**SUBDIVISION REVIEW SHEET
(VARIANCE ONLY)**

CASE NO.: C8-2018-0108

SUBDIVISION NAME: Mount Moriah

SUBJECT: Mount Moriah Subdivision (C8-2018-0108)
Variance of Title 25, Section 25-4-151 (Street connection)

JOB NUMBER: A380-0401
SHEET NO.: SP01
OF 03 SHEETS

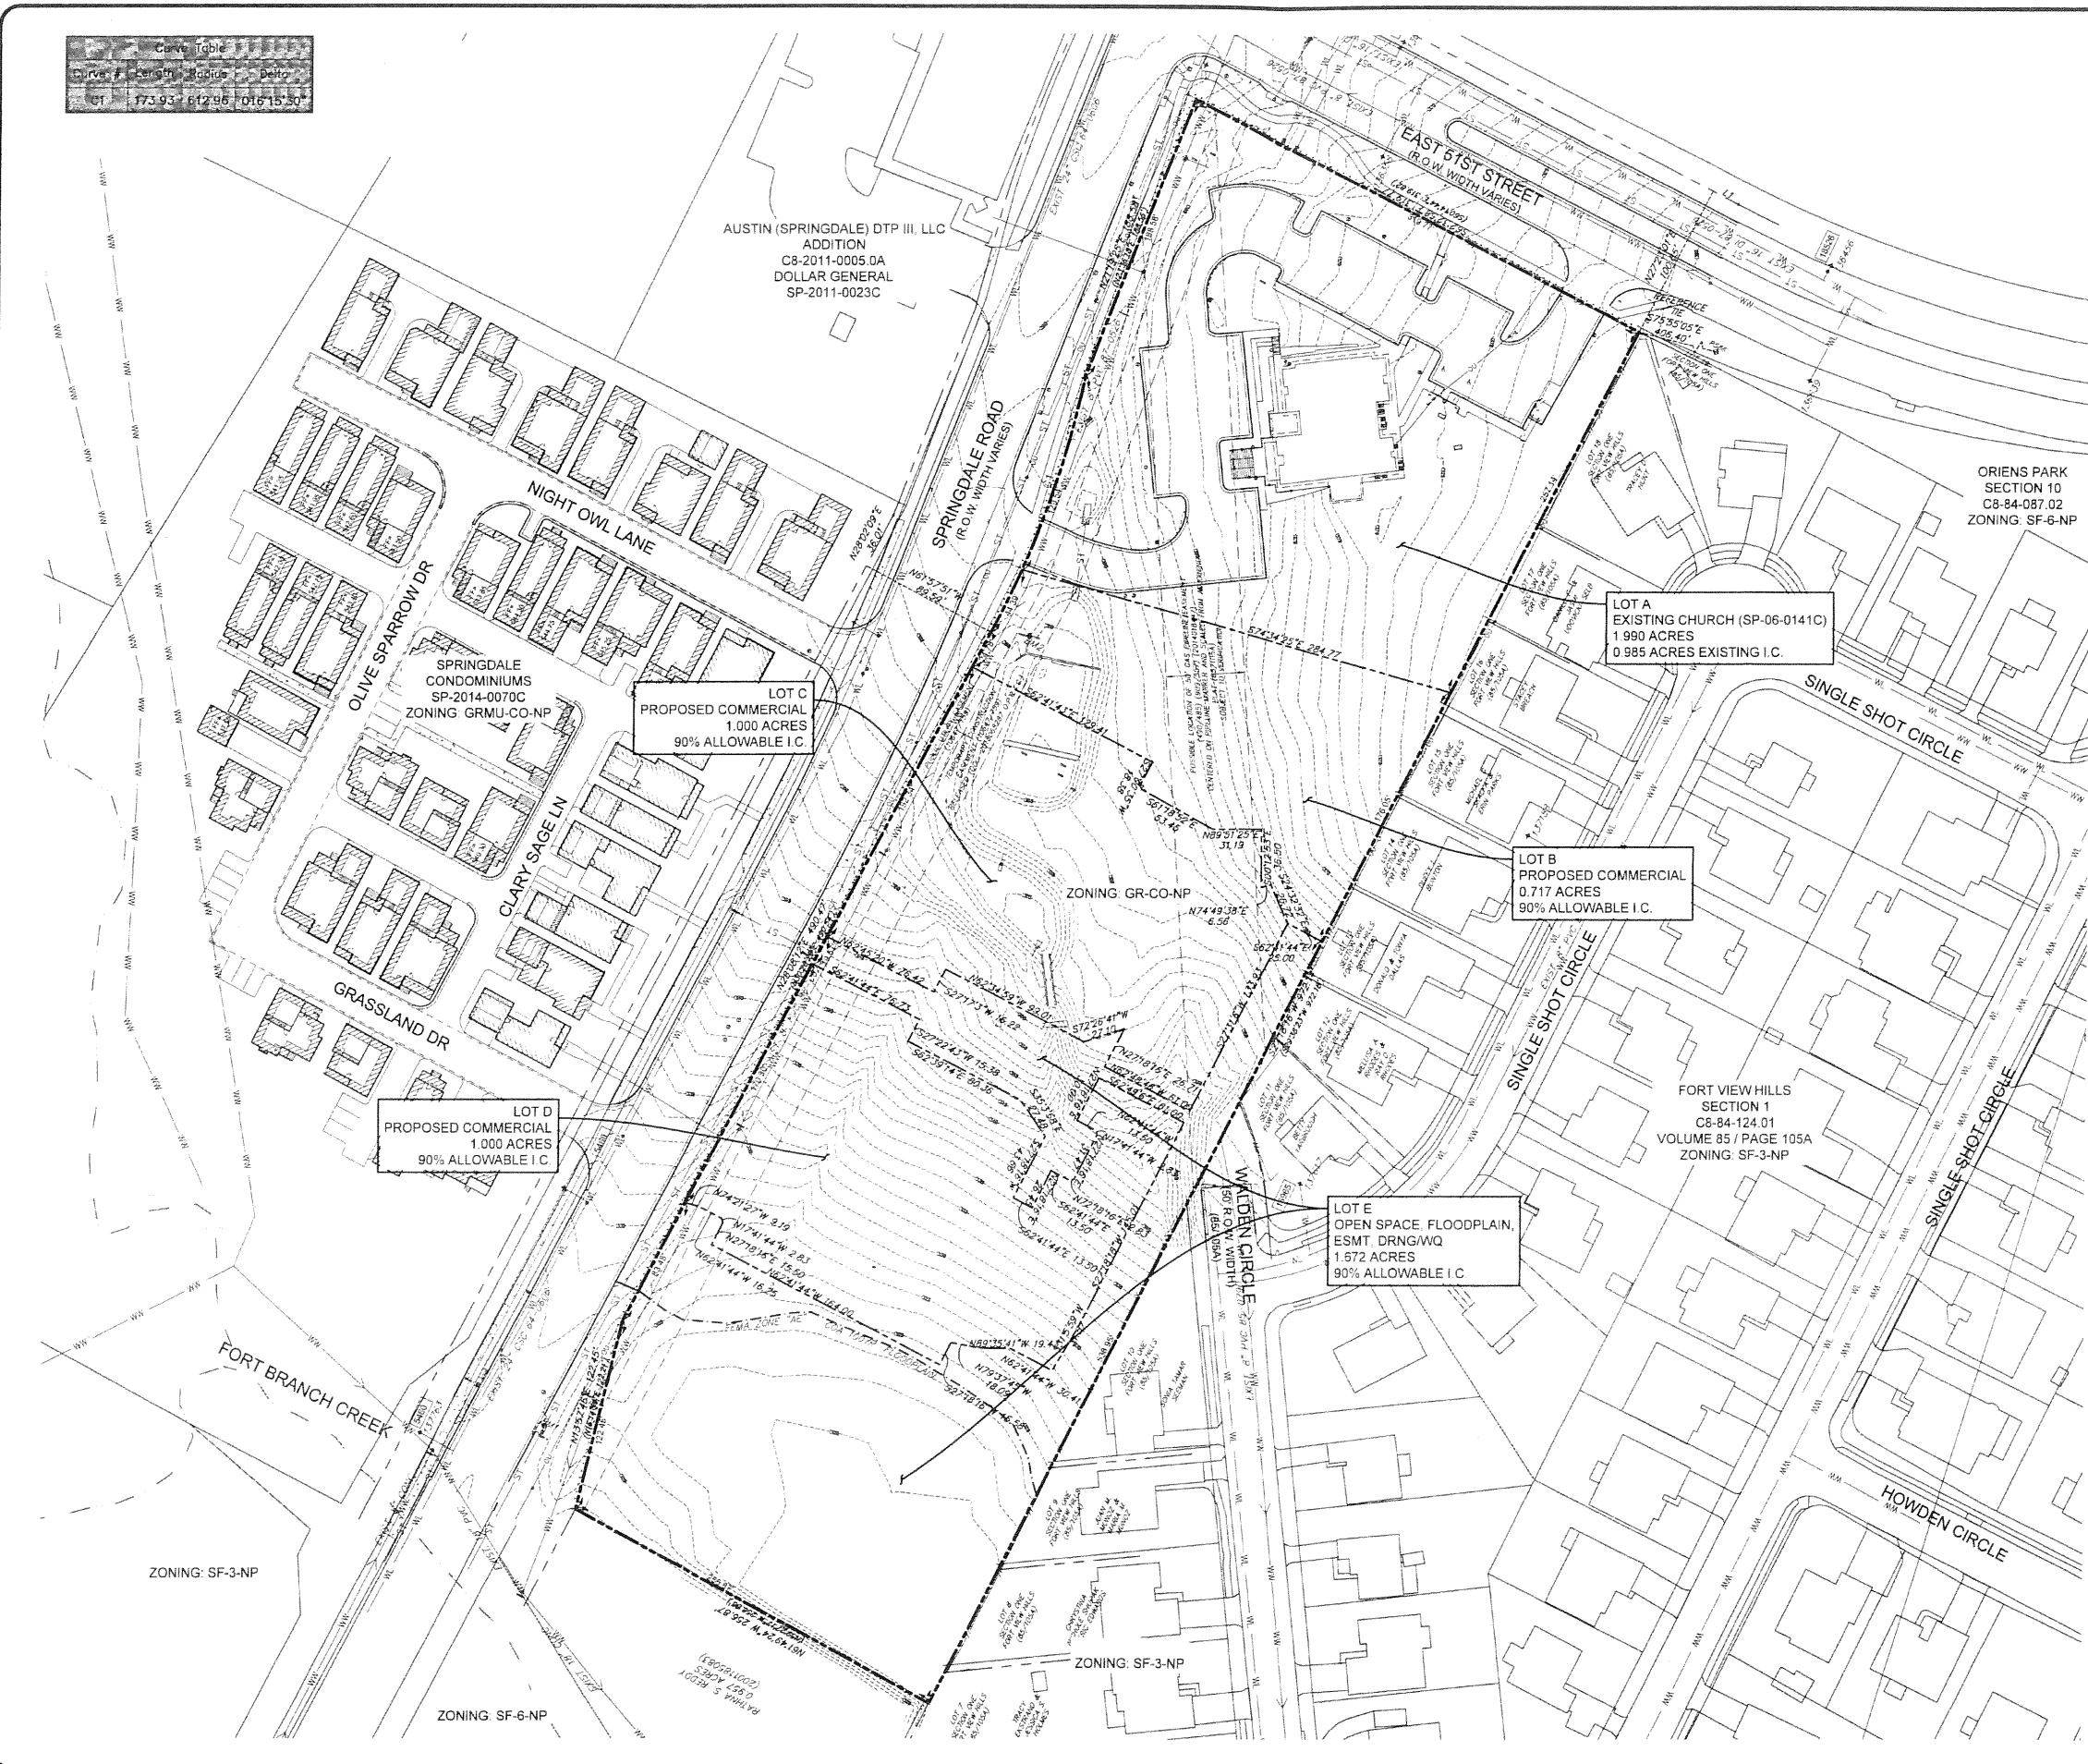
The applicant for the above referenced subdivision is requesting a variance to Title 25 of the Land Development Code (LDC) to not extend Walden Circle, a local residential street, to Springdale Road through the subject property. Per LDC 25-4-151, streets of new subdivisions are required to align with and connect to existing streets on adjoining property unless the Zoning & Platting Commission determines that the Comprehensive Plan, topography, requirements of traffic circulation, or other considerations make it desirable to depart from the alignment or connection.

The subject 6.378-acre tract is located within the City of Austin's full purpose jurisdiction at SE corner of the Springdale Road and E. 51st Street intersection. Currently, the tract is developed and contains a church building, the parking lot, detention and water quality ponds, and associated utilities. The tract is planned to be subdivided to retain the existing church building in one 1.99-acre lot and to subdivide the remaining 4.389-acres into four lots. Please see the enclosed preliminary plan.

- The subject tract has several site constraints that would make the extension of Walden Circle not feasible. The existing topography at the end of Walden Circle is very steep with grades exceeding 35% which would require an environmental variance.
- Walden Circle is aligned and currently terminates into an existing 50 ft. wide gas pipeline easement which does not allow any grade changes over such pipeline. Based on the existing

topography, a roadway cannot be designed thru this property without significantly altering the existing grade over the pipeline.

- The subject tract and other existing residential properties located behind this development will be adequately served by the current street network.
- The applicant has demonstrated good faith in studying the extension of Walden Circle but is not able to due to circumstances out of their control. Consequently, the neighborhood group has not expressed any concerns to the applicant's request to not extend Walden Circle thru this property.
- Per LDC, 25-6-101, additional improvements may be required during the site plan stage for compliance with the City's Mitigation Ordinance No. 20170302-077.

RECOMMENDATION: Staff recommends the variance with conditions
